**FAO:** An Bord Pleanála (Strategic Infrastructure Division)

**Re.** Planning Application by the National Transport Authority for the construction of the Belfield / Blackrock to City Centre Core Bus Corridor Scheme.

The Submission from Dun Laoghaire Rathdown County Council regarding the Belfield / Blackrock to City Centre Core Bus Corridor Scheme is set out hereunder.

### **Traffic Reassignment**

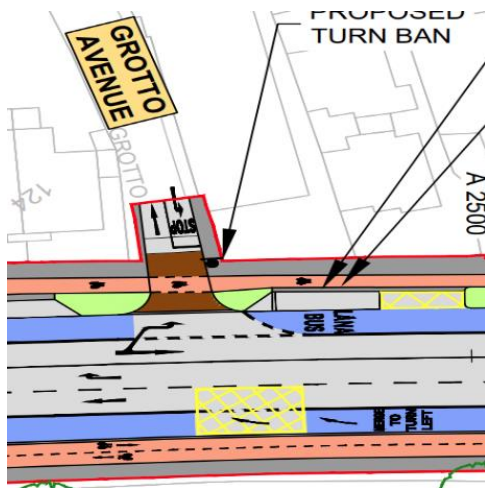
Chapter 6 of the EIR deals with Traffic and Transport. Section 6.4.6.2.8.3 deals with differences in traffic flows on links in the study area. Diagram 6.27 shows the AM peak hour in 2028. It shows significant increases in traffic along Stillorgan Park Road and Grove Road. The Council is currently considering Active Travel measures along Stillorgan Park Road and in the area of Grove Road and nearby Avoca Road. The Council believes that traffic is more likely to reassign (i.e. re-route) to Stillorgan Park Road and the Stillorgan Road between Stillorgan Village and Mount Merrion Avenue, especially when our Active Travel measures are implemented. The Diagram also shows increased car traffic along all other sections of the Bray/Stillorgan Road from White's Cross to the City Centre. The Council is of the view that the best way to mitigate the impacts of such car traffic reassignment would be to expedite the approval and construction of the Bray Core Bus Corridor, thereby providing a sustainable travel option for people in the general area.

### Example 2

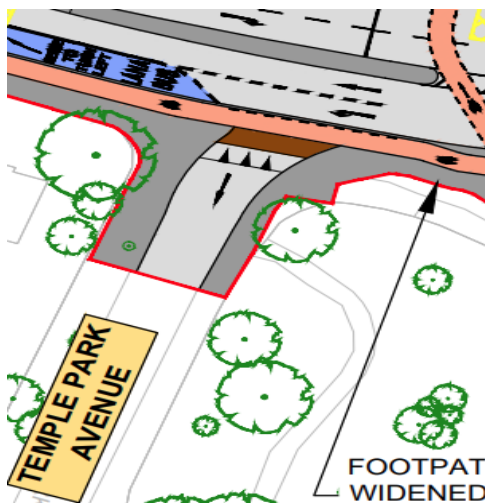
In the interest of pedestrian and cyclist safety, DLRCC has a requirement, where feasible, for the provision of continuous pedestrian and cycle facilities across side roads, similar in design to that proposed under the CBC scheme at Grotto Avenue (example 1 below). At other side road locations across the CBC scheme however, the cycle lane is at grade with the general traffic lane and not accommodated on the raised table (example 2 below).

**DLRCC requests that the Board include a condition requiring prior engagement and agreement with DLRCC regarding the final design of the pedestrian and cycle facilities at junctions with side roads in order to ensure an approach which is consistent with the requirements of the Council.**

### Segregated Cycle Facilities at Temple Hill – Monkstown Rd Junction

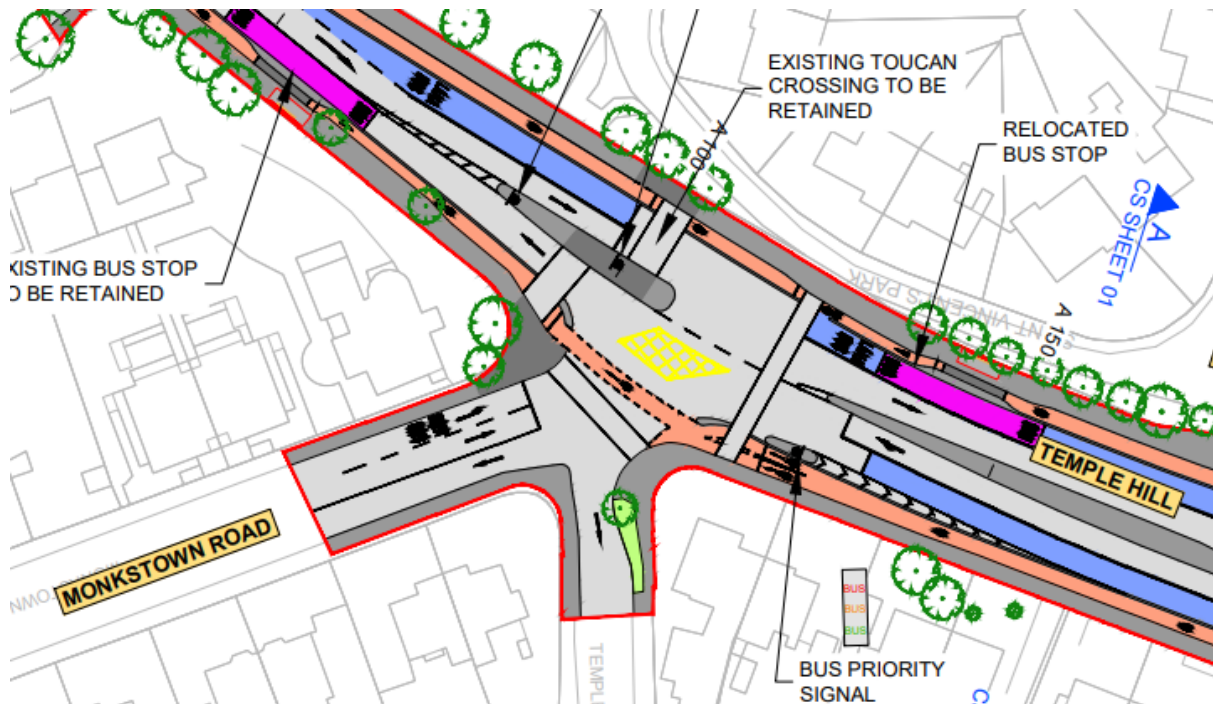
The CBC scheme proposes segregated cycle facilities on the city bound cycle lane as it passes through the junction of Temple Hill and Monkstown Rd. While DLRC generally favours segregated facilities, there is a concern at this location, that the segregated design could impede cyclists coming from Monkstown Rd and wishing to continue straight through the junction and access the city bound cycle lane directly (rather than alighting and using the Toucan Crossing).

**DLRC requests that the Board considers a minor design amendment at this junction, to allow for safe access to the city bound cycle lane through the junction for cyclists coming from Monkstown Road.**

## Proposed Junction at Mount Merrion Avenue and Rock Road

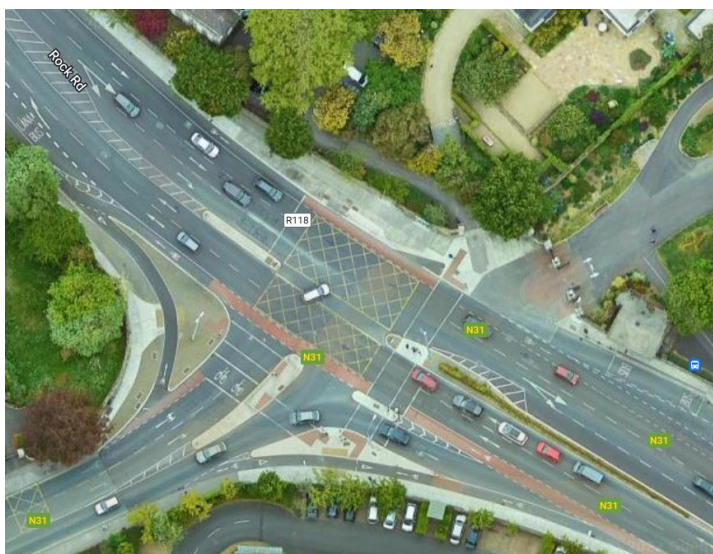
DLRCC has concerns that the proposed cycle lane on Mount Merrion Avenue leading to Rock Road is quite narrow for such a busy route. In addition, there are concerns that the proposed junction design, which omits the existing left turn cycle slip lanes leading from Mount Merrion Ave. to Rock Rd and from Rock Road to Mount Merrion Ave, will result in a reduced level of service for cyclists. DLRCC requests the left turn cycle facilities (as currently exist) be incorporated into the proposed junction design to improve convenience for cyclists and avoid unnecessarily bringing cyclists through the signalised junction. DLRCC considers that ample space is available to safely accommodate these amendments and give extra priority for cyclists.

**DLRCC requests the Board to include a condition requiring the amendment of this junction design to include a wider cycle lane on Mount Merrion Ave leading to the junction and to incorporate the left turn cycle facilities (as currently exist). The final layout and design of this junction to be submitted for the prior agreement of DLRCC.**

### Right Turn Filter Lane on Rock Rd for access to Castledawson and Westfield

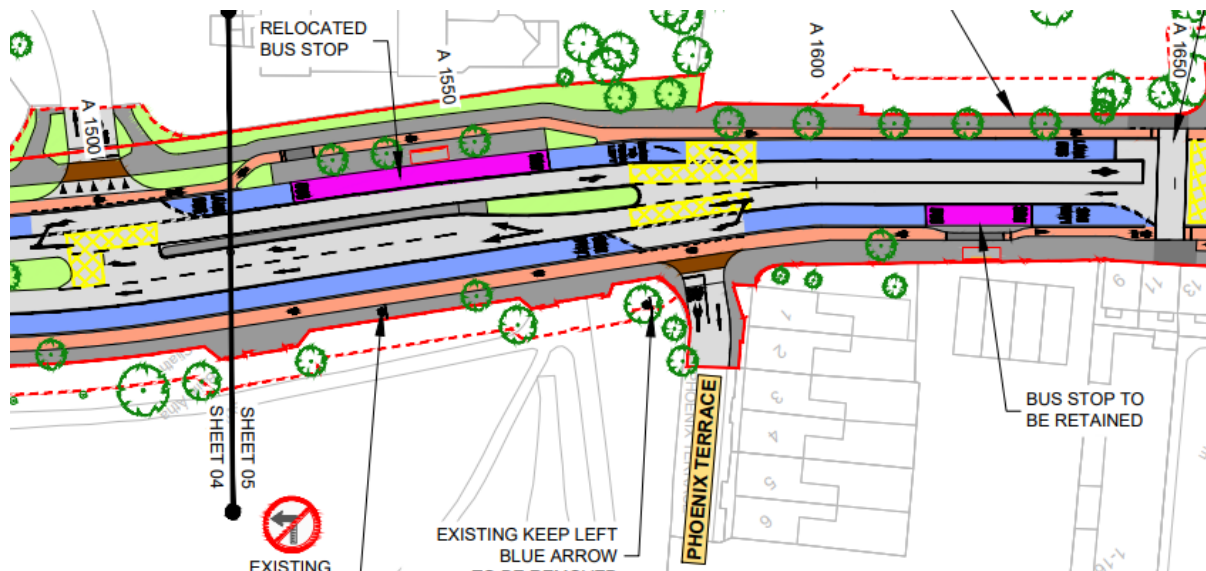
DLRCC is concerned that the proposed right turn filter lane on Rock Rd for access to Castledawson and Westfield, is excessive and could be reduced with the planted median extended or incorporated into a SUDS solution. This would also help to soften the public realm at this busy traffic location. In addition, DLRCC notes that there is a strong pedestrian desire line across the Rock Rd at this location leading from the Castledawson and Westfield residential estates to/from Blackrock Park. The nearest pedestrian crossing facilities at either Mount Merrion Avenue or Blackrock Clinic are not convenient and the Board is requested to consider including a requirement for a pedestrian crossing facility to be included in this vicinity with location and design to be subject to prior engagement and agreement with DLRCC.

**DLRCC requests the Board to consider reducing the length of this right turn filter lane and allowing for an extended planted median at this location together with the provision of a pedestrian crossing in the vicinity with the layout and design of any amendments to be subject to prior engagement and agreement with DLRCC.**

### Entrance to Castledawson and Opposite Blackrock Park

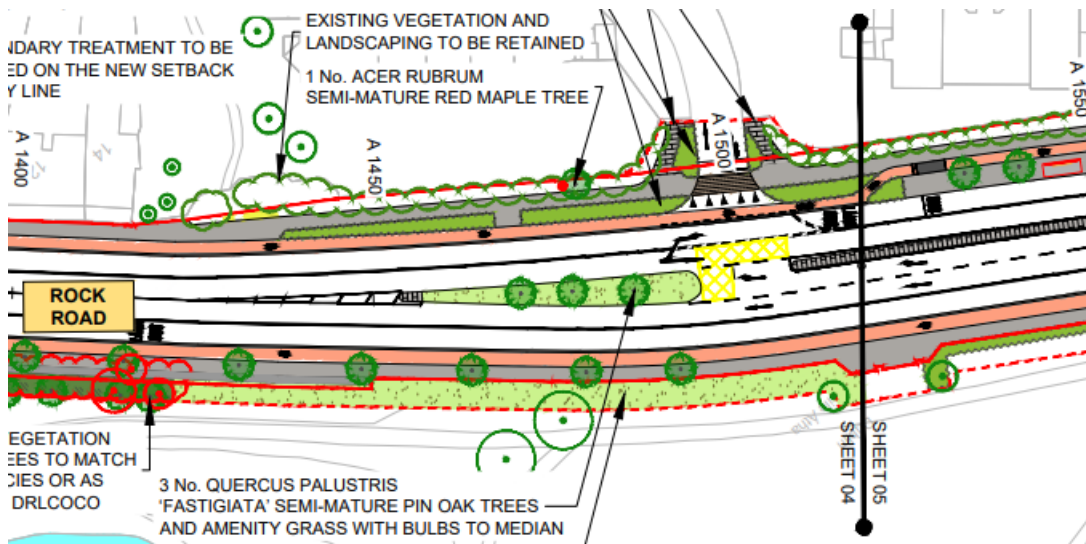
The large green areas shown below opposite Blackrock Park and adjacent to the entrance to the Castledawson estate, have the potential to incorporate trees. DLRCC considers trees essential along this stretch of carriageway, which is wide and in an exposed coastal location.

Trees, however, may not be possible within the narrow footpath section adjacent to Blackrock Park and shown above. DLRCC questions the need for the kick in the footpath making it narrower at this location.

## Willow Terrace

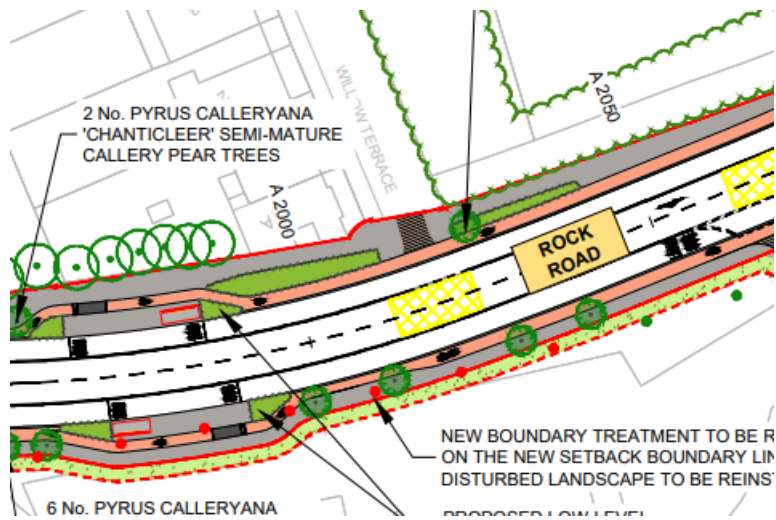
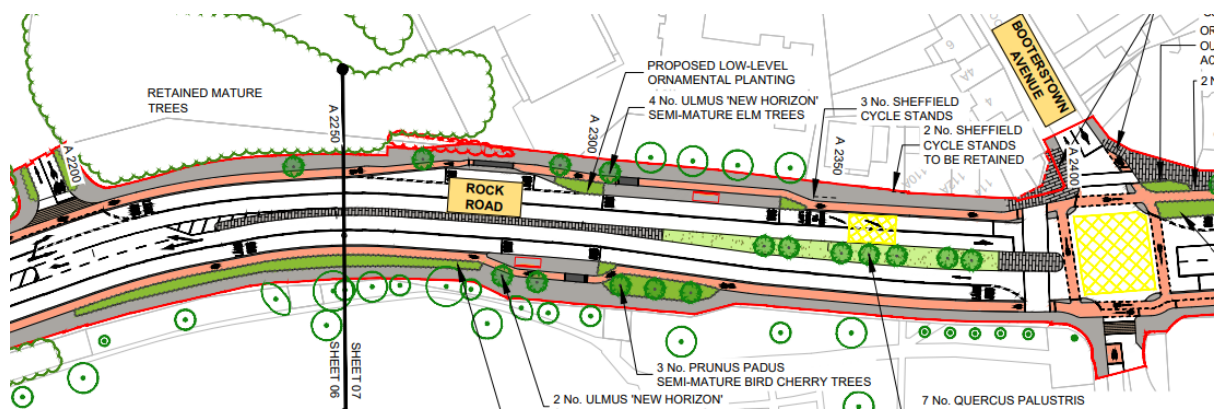
The green areas shown below adjacent to the entrance to Willow Terrace and adjacent to Blackrock Park, have the potential to incorporate trees. DLRCC considers trees essential at these locations, where the carriageway is wide and in an exposed coastal area.

## Landscaped Median on Temple Road

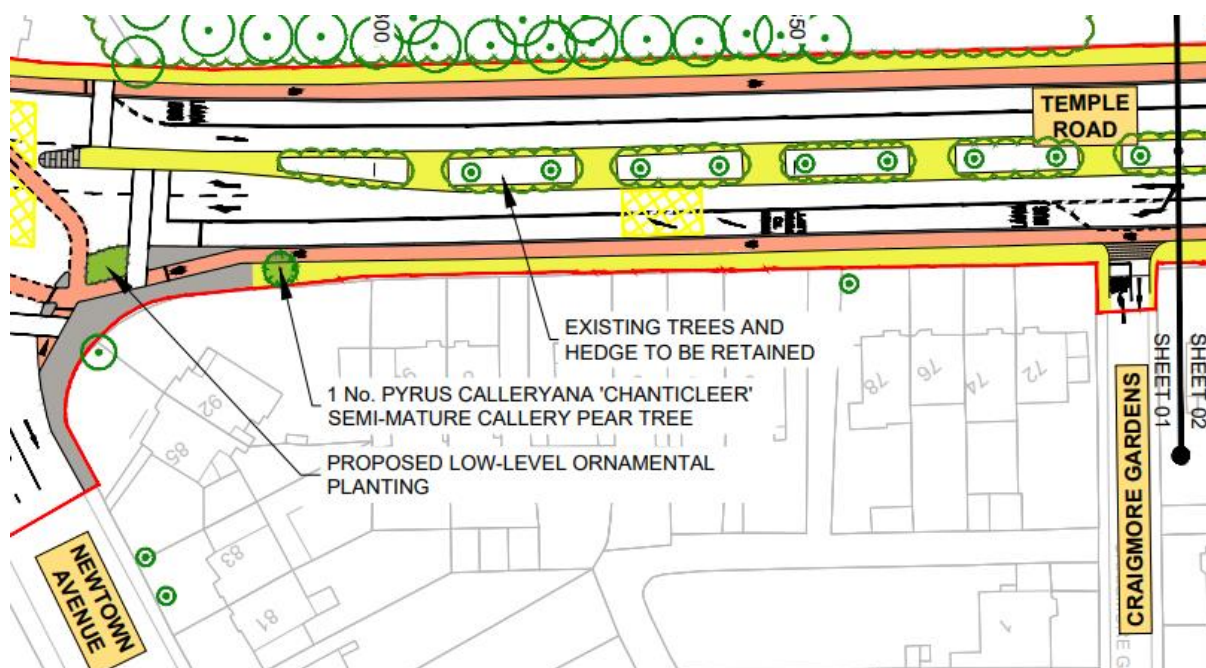
In the interest of achieving a coordinated and coherent landscape response across the proposed corridor, DLRCC requests that the landscaped median on Temple Rd, shown below, be included in the landscape design for the scheme with the existing Buxus groundcover to be replaced with a herbaceous mix with all soft landscaping to be amalgamated into one large bed and extended out to the kerb lines.
